Product Change Notice (PCN)

PCN Number: **PCN-0451213R-01**

Product(s) Affected: **PJ-059BH**

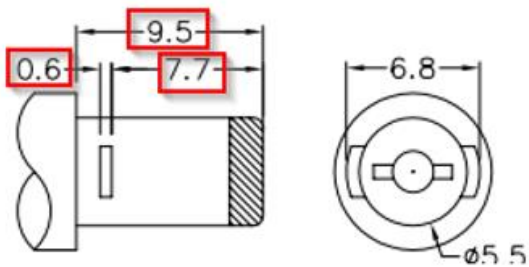
Description of Change: **Minor Housing and footprint differences. Material Change on the housing and terminals. See image Below**

MATING PLUG
Jack Insertion Depth: 9.8 mm

MATING PLUG
Jack Insertion Depth: 9.5 mm
